ROZELLE INTERCHANGE – ACTIVE TRANSPORT NON-COMPLIANCE AND DEFECTS REPORT

Prepared for
Department of Planning, Housing and Infrastructure, Transport for NSW, Sydney
Transport Partners, and Inner West Council

by
Rozelle Parklands Active Transport and Community Hub Incorporated

February 2024

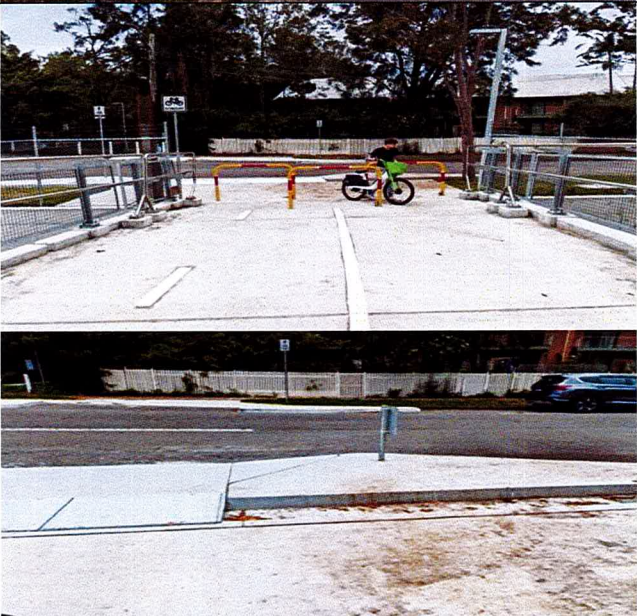
Item	Problem	Recommendation	Illustration
1	Ryan St/Lilyfield Rd access to Parklands is dangerous	<p>Provide a properly designed entrance that has good sight lines, a safe combined bicycle and pedestrian crossing with smooth mesh ramping to cope for pedestrians, disability users and cycle riders.</p> <p>See below Ryan St crossing design by Complete Urban for Lilyfield Rd cycleway.</p>	 <p>The illustration consists of three photographs. The top photograph shows a street-level view of a yellow ramp installed on a sidewalk, with a blue-painted bicycle symbol on the pavement nearby. The middle photograph is a close-up of the yellow mesh ramp, showing its texture and the red and white striped safety tape applied along its edges. The bottom photograph is a technical site plan or engineering drawing, showing a top-down view of the crossing area with various lines, dimensions, and labels indicating the layout of the ramp and surrounding infrastructure.</p>

Item	Problem	Recommendation	Illustration
2	Easton Park entrance to Parklands has no safe crossing of Lilyfield Rd	Provide a safe combined bicycle and pedestrian crossing that links to paths in Easton Park.	
3	Gordon St entrance unsafe	Redesign Gordon St/Lilyfield Rd intersection to cater for new usage. Move raised section to the centre of the intersection. Remove northbound slip lane into Gordon St. Provide for right turn cycle movement off Lilyfield Rd into Parklands. Provide safe northbound exit of Parklands across Lilyfield Rd into Gordon St by cyclists. Remove dangerous lip on

Item	Problem	Recommendation	Illustration
4	Turn into Lilyfield Rd from Victoria Rd is dangerous for cyclists, with no permanent clear warning to motorists of cyclists' presence	<p>driveway into Parklands.</p> <p>Provide formal pedestrian/cyclist crossing of Lilyfield Rd further west of Victoria Rd to allow safe passage of cyclists across Lilyfield Rd and clear notice to motorists of cyclist/pedestrian presence and movements.</p>

Item	Problem	Recommendation	Illustration
5	Gordon St uphill cycle route is unsafe	Provide differential lane treatment between on Gordon St northbound between Lilyfield Rd and Victoria Rd. Remove car parking on west side and provide a clear delineated cycle lane.	 A photograph of a street scene. In the foreground, there are three signs on a metal post. The top sign is orange with a black bicycle icon and the text 'WATCH FOR BICYCLIST'. Below it is a white sign with a red border that reads 'NO 2P LISTS USE LANE'. To the right, on a separate post, is a circular speed limit sign with the number '50'. The street is paved and has a concrete curb on the left. A white car is driving away in the distance. The background is filled with green trees under a clear blue sky.

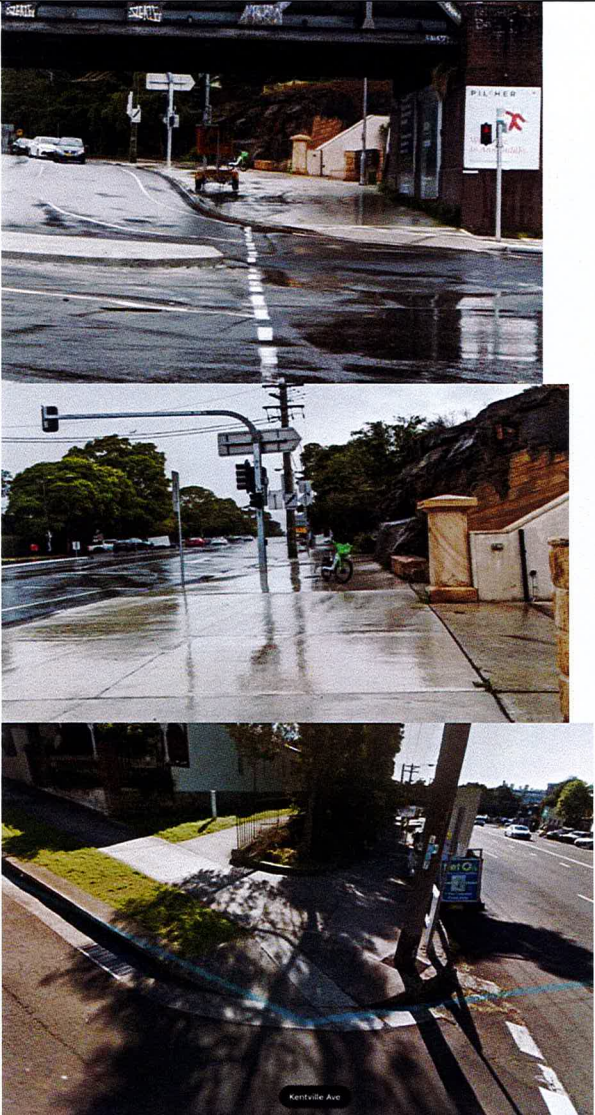
Item	Problem	Recommendation	Illustration
12	<p>Cycle movement for Annandale residents to access Glebe Foreshore Parks has been made inconvenient and unsafe because of the widened roadways at The Crescent and Johnston St intersection</p>	<p>Provide safe and clear cycle facilities suitable for children and families through this intersection, including cycle lanes on the northern end of Johnston St and ways of crossing Johnston St at the new intersection.</p>	 <p>The illustration consists of three photographs. The top photo shows a street intersection with a white dashed line down the center and a 'PILMER' sign on the right. The middle photo shows a street intersection with a traffic light and a person on a bicycle. The bottom photo shows a street intersection with a blue-painted cycle lane and a 'Kerrville Ave' sign.</p>

Item	Problem	Recommendation	Illustration
13	Southbound lane on The Crescent under the Light Rail bridge has no cycle lane, despite adequate space available	Provide a cycle lane for cyclists to allow safe south bound cycle movement along The Crescent towards Annandale, Glebe, Camperdown and Sydney University.	 A photograph showing a road under a bridge. A newly paved asphalt lane runs parallel to the road. A yellow and black striped bollard is placed at the edge of the lane. In the background, a person is riding a bicycle, and a white car is visible. A billboard for DoorDash is visible on the left side of the road. The billboard text reads: "LESS COOKING, MORE EATING. DOORDASH. TAP INTO HOLIDAY MODE."

Item	Problem	Recommendation	Illustration
14	No direct access from Parklands to White Bay Power Station site	Provide a cycle /pedestrian link from the Anzac Bridge cycleway across to Roberts St via White Bay precinct. Would improve Balmain access to the Parklands. Could also be a very useful active transport link for future Biennale exhibitions patrons.

Item	Problem	Recommendation	Illustration
15	Current 50km/h speed limits on streets adjacent to the Rozelle Parklands are too high, given the changed usage and character of the area	Lower speed ratings on Gordon St (from Victoria Rd to across Lilyfield Rd into Parklands), Brenan St and Railway Pde, and Lilyfield Rd from Victoria Rd to Ryan St. These are all Low Traffic Neighbourhoods and should be progressively lowered to 30km/h.

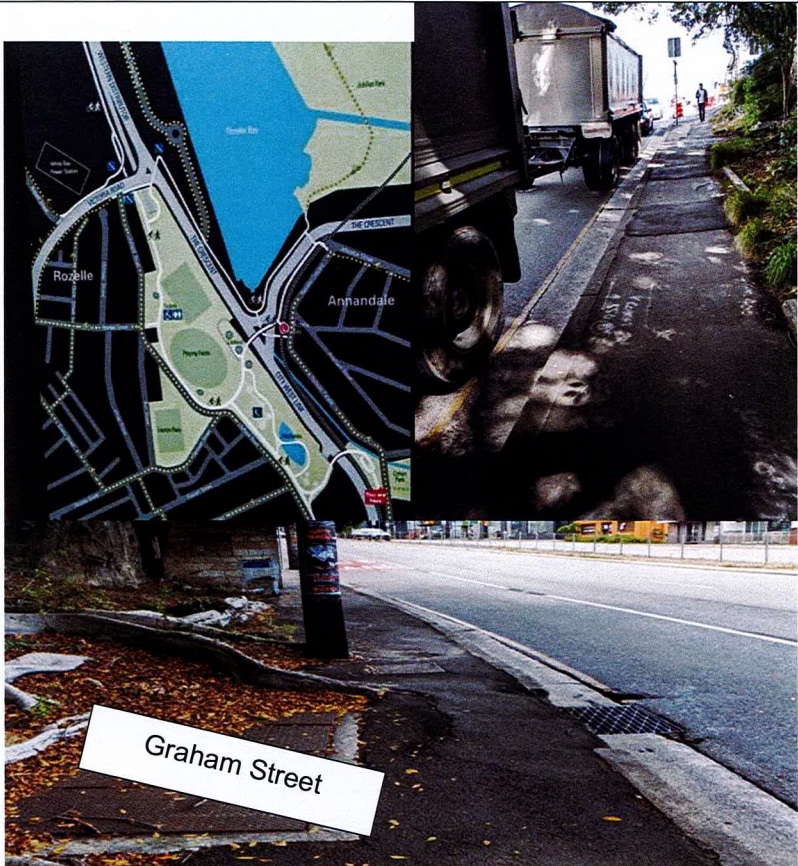
Item	Problem	Recommendation	Illustration
16	<p>Some signage maps within Parklands are misleading and dangerous. The narrow section of 'footpath' on Victoria Rd between Quirk and Maney Sts is unsuitable for cycling as riders could easily fall onto the busy roadway</p>	<p>Cycle movement from Quirk to Maney adjacent to Victoria Rd should be barred by appropriate physical barriers and alternative route signage be installed. Parklands information signs and maps to be updated to reflect this change.</p>	 <p>The illustration consists of two parts. On the left is a map showing the area around Parklands, with labels for 'Rozelle', 'Annandale', and 'The Crossing'. A blue area represents 'Travis Bay'. On the right is a photograph of a narrow footpath on Victoria Rd. A large truck is parked on the road, and a person is walking on the footpath. A signpost on the sidewalk is labeled 'Graham Street'.</p>

Item	Problem	Recommendation	Illustration
17	Dog leash areas close to designated shared cycleways can be dangerous, especially for child riders	<p>(NOTE: council site says no off-leash areas in Rozelle Parklands)</p> <p>Council must designate dog off-leash areas away from shared cycleways. The Balmain Rd Sporting Ground should not have an off-leash area as portion of these grounds could be used in future to provide a cycle/pedestrian path inside the Callan Park from Wharf Rd to Cecily St, avoiding the busy and unsafe Balmain Rd.</p>	<p>Parks with off leash areas</p> 
18	The 90deg angle parking proposed for Lilyfield Rd (presumably between Gordon St and Ryan St) could cause danger to passing cyclists and present sight problems for motorists	Council must indent the parking into the Parklands in this section so that adequate cycle lane width is maintained on Lilyfield Rd.

Item	Problem	Recommendation	Illustration
19	Catherine St intersection on Lilyfield Rd is dysfunctional and dangerous to cycle and pedestrian movements	Provide a pedestrian/cycle crossing on the northern end of Catherine St and formalise northbound cycle movement on Catherine St by appropriate legal treatments providing protection for cyclists and clear guidance for motor vehicle movements.

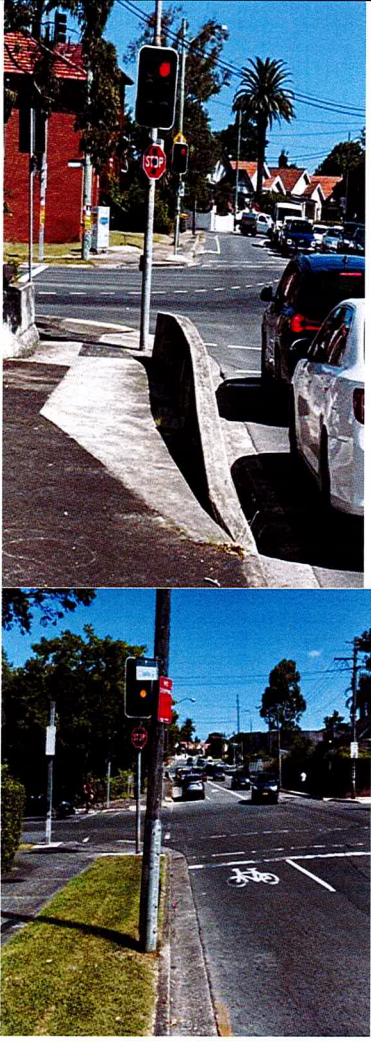
Item	Problem	Recommendation	Illustration
20	Cycle lanes on Balmain Rd between City West Link and Lilyfield Rd are discontinuous, making this a barrier to safe cycle movement across this major intersection	Reconfigure lanes and unused footpath space on east side of rail bridge and CWL crossing to facilitate continuous north/south safe cycle movement on <u>both</u> sides of Balmain Rd.	 <p data-bbox="1630 683 1783 740">Balmain Rd, East side</p>

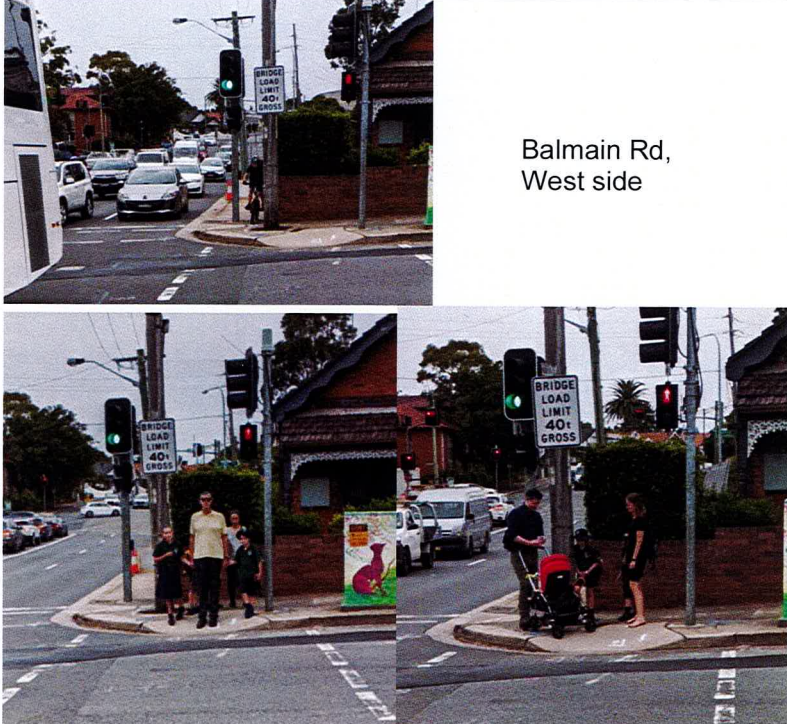
Item	Problem	Recommendation	Illustration
20 (cont)			 <p data-bbox="1646 383 1803 438">Balmain Rd, West side</p>

21	Lilyfield Rd gradient between Hawthorne Canal and James St intersection presents a challenge for inexperienced cyclists	Investigate an off-road route between Hawthorne Canal and Balmain Rd intersection in a corridor between the City West Link soundwall and adjacent properties, offering a preferable gradient (<i>see B Ashley Plan - 2019 below</i>)	
----	---	--	--
